APPLICATION FOR ZONING CHANGE

Date 2-25-91NAME OF PROPOSED DEVELOPMENT Steger Retail AdditionLOCATION OF PROPOSED DEVELOPMENT N.E. corner of FM 740 and  
FM 3097NAME OF PROPERTY OWNER/DEVELOPER Estate of O.L. Steger, Jr. and Emily Sue  
Whitehead  
c/o Lakeside National BankADDRESS P.O. Box 9PHONE (214) 771-8311Rockwall, Texas 75087NAME OF LAND PLANNER/ENGINEER Winkelmann & Associates, Inc.ADDRESS 12800 Hillcrest Road, Suite 200PHONE (214) 490-7090Dallas, Texas 75230TOTAL ACREAGE 4±CURRENT ZONING ANUMBER OF LOTS/UNITS 1PROPOSED USE FOR DEVELOPMENT Grocery Store

FOOD LION, INC. SITE #50a  
F.M. 740 @ F.M. 3097  
Rockwall County  
Rockwall, Texas

I have reviewed the preliminary information that has been submitted in conjunction with this request. Additionally, the Planning and Zoning Commission reviewed the plans in their last worksession and our comments regarding the proposed development are as follows:

JOB NO.	91-06
DATE	3-19-91
DRAWN	M.T.B.
CHK	J.D.H.
SHEET	A-3
OF 19	
EXTERIOR ELEVATIONS	
3390-DB 1Z

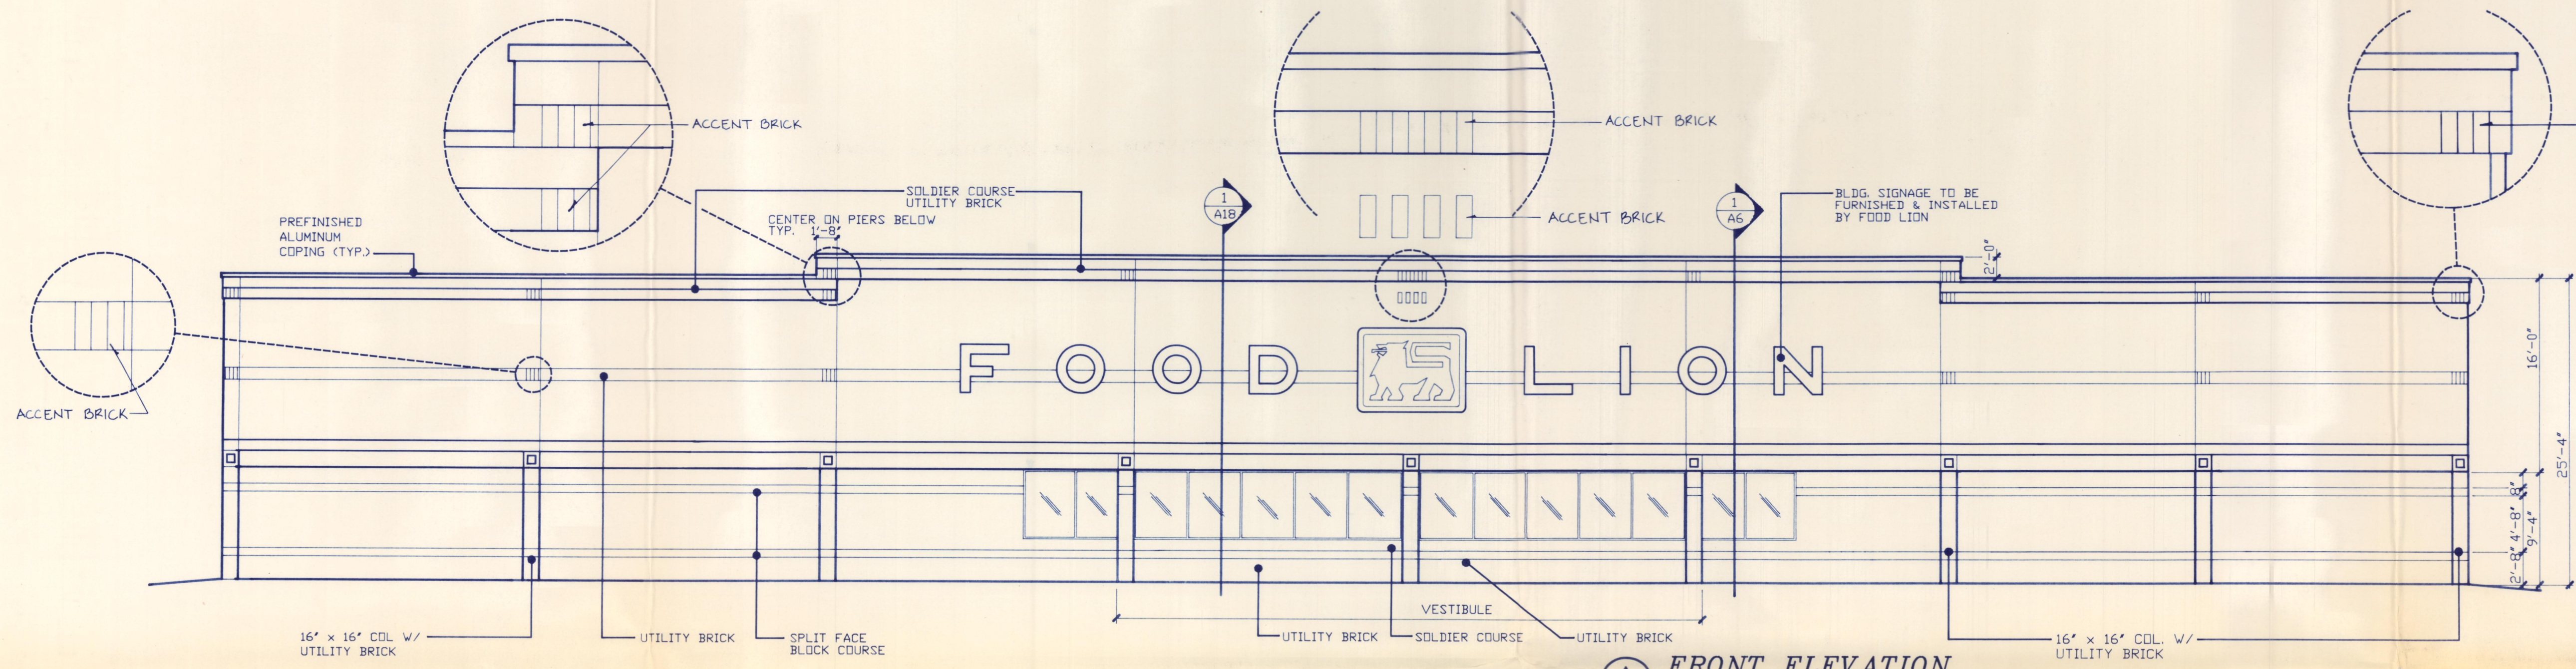
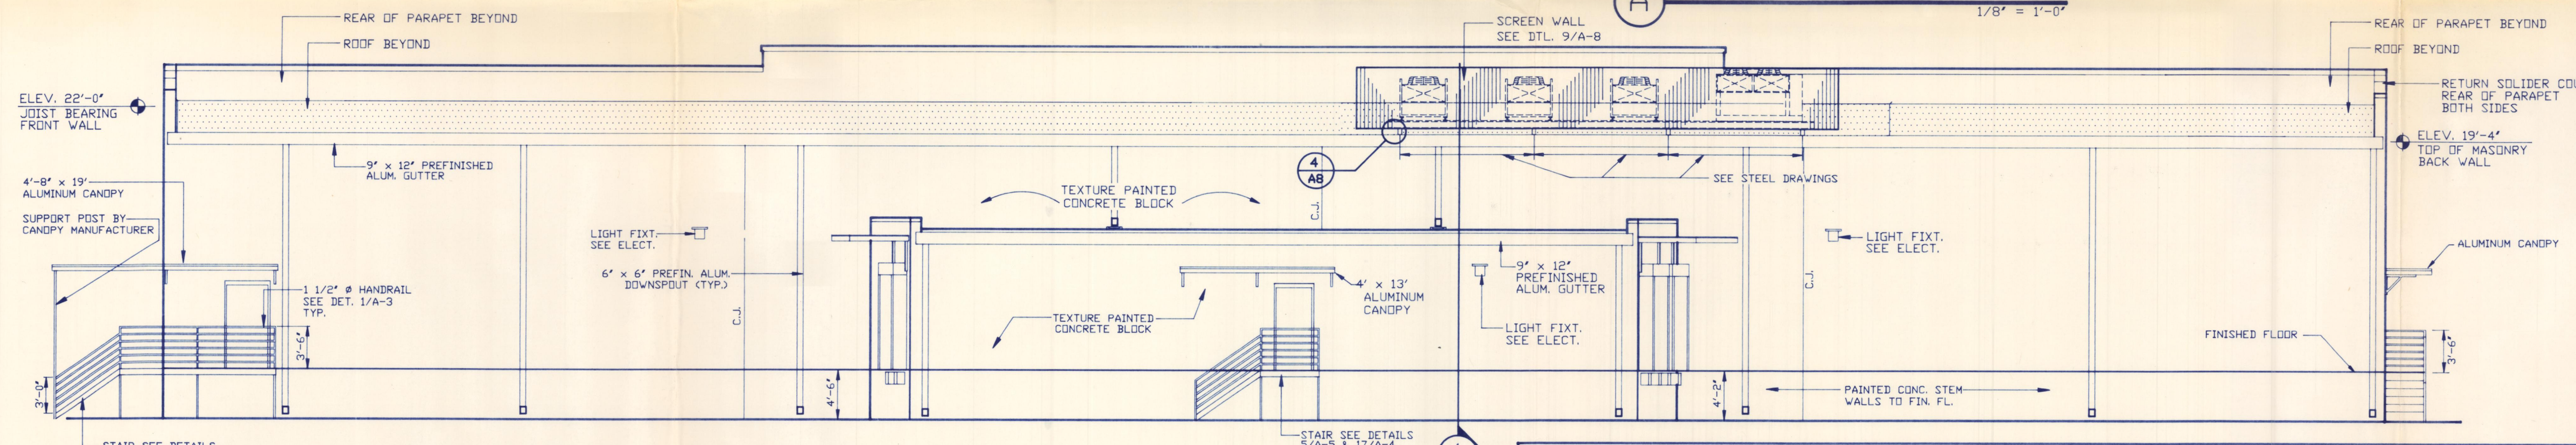
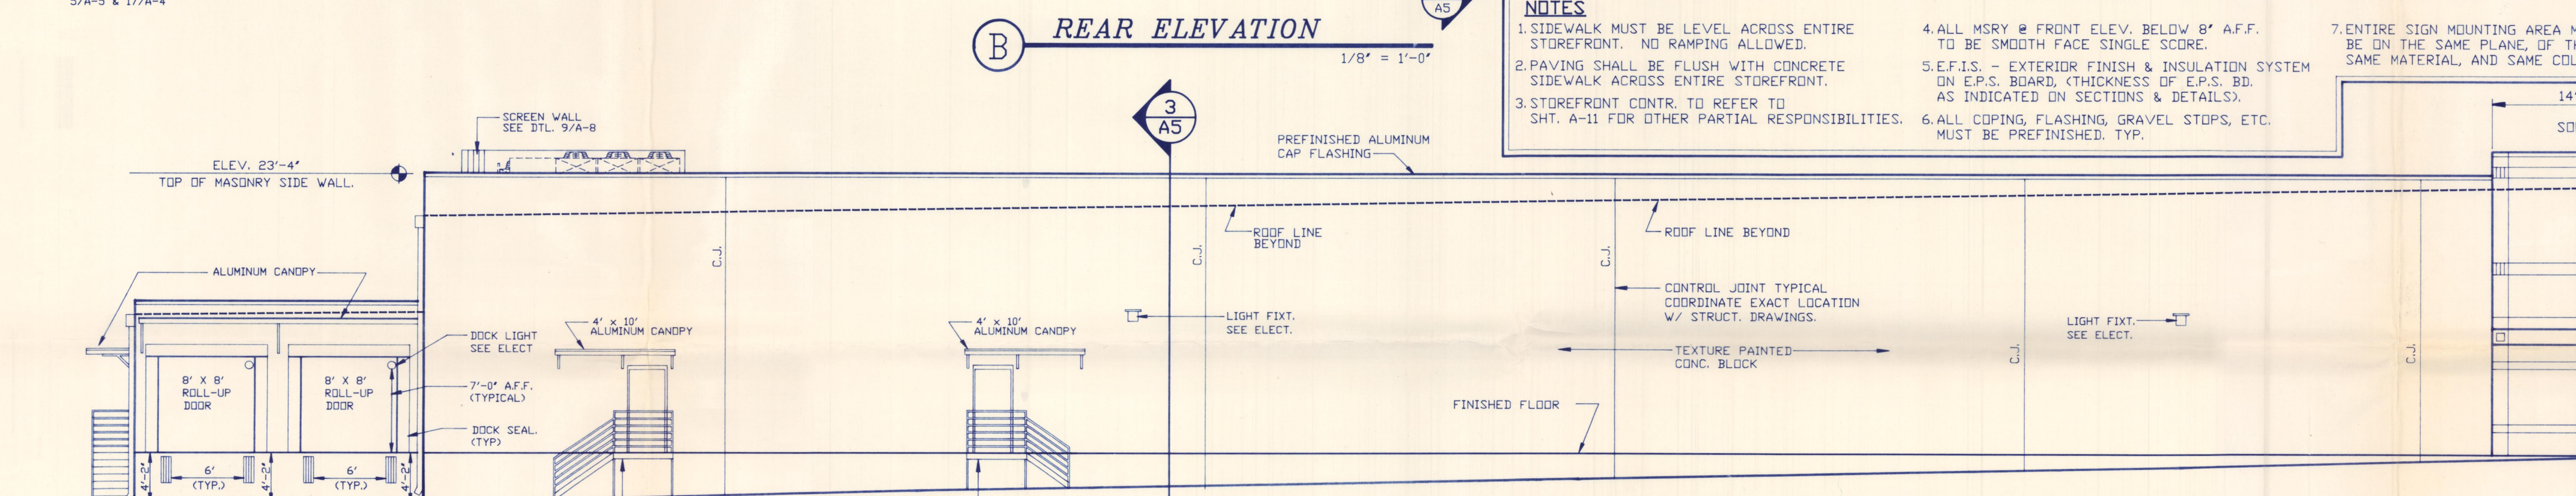
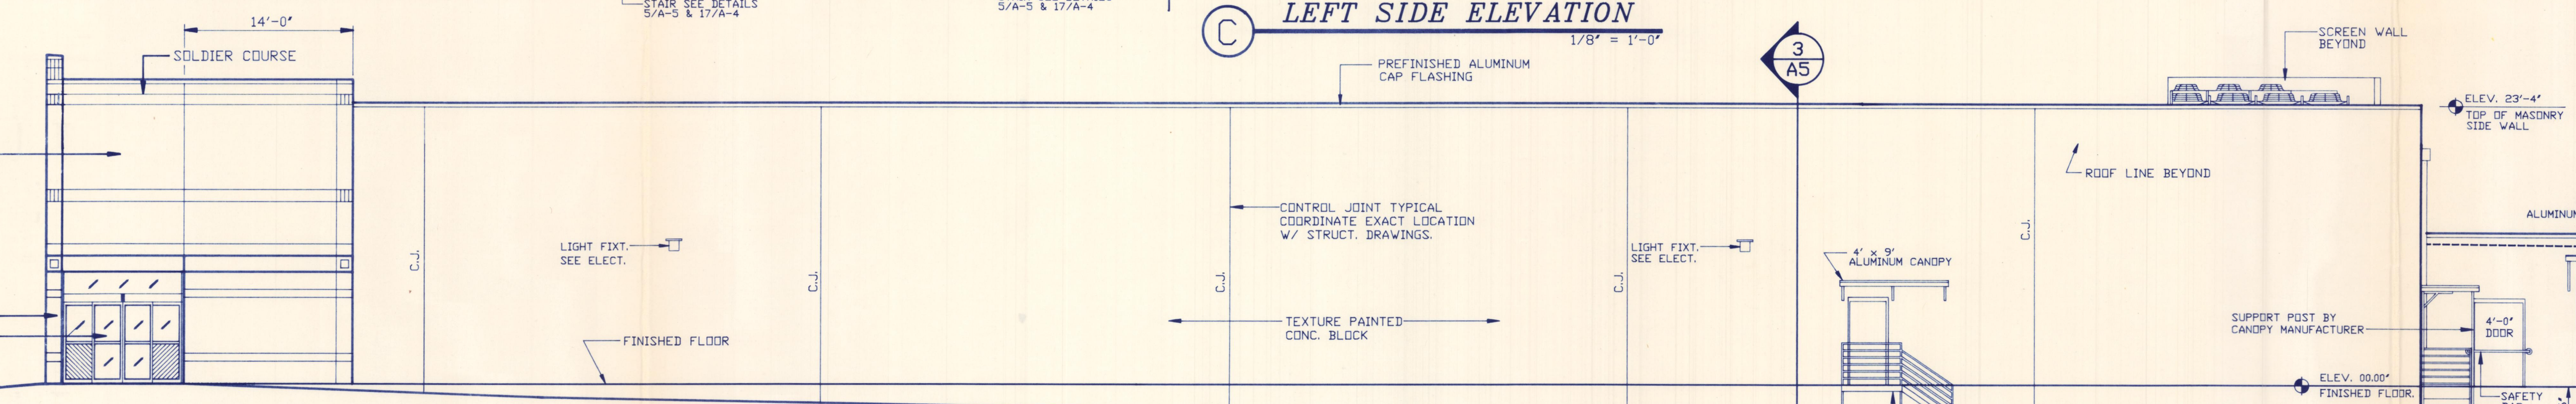
add variations & color to top &  
Bottom on front elevations

add Brick to 8+18 on both sides

1. The building facade in front is not like the facade approved at the other location. The previous location included a taller front parapet with wrap around brick to give the facade more substance. The Commission will want to know why this change was made. One of the purposes of the wrap around on the sides was to help screen the roof mounted deli utility equipment. Will this equipment be used in this building?

2. What type of roof mount screen will be used around the utility equipment to the rear and will that screen be used on three sides?
3. The previous plan included brick around all four sides of the building. This location will not have the visibility of the previous location but the sides will be totally visible until there is additional development. Even when additional development occurs some of the sides will continue to be visible. The Commission expressed some concern about this issue. There is additionally no guarantee that future buildings will be located adjacent to this building. The Commission also expressed concern about the use of concrete block. There was some discussion about a stucco type paint material that might be used to surface the block. You need to be prepared to discuss this issue at the Architectural Review meeting as I am sure that it will be raised.

4. Please identify the material for the screens around the dumpster locations. It generally should match the material on the main structure.
5. Will the stairs in the rear be of the same bronze color as the coping along the top of the building? They were planned to match under the previous plan.
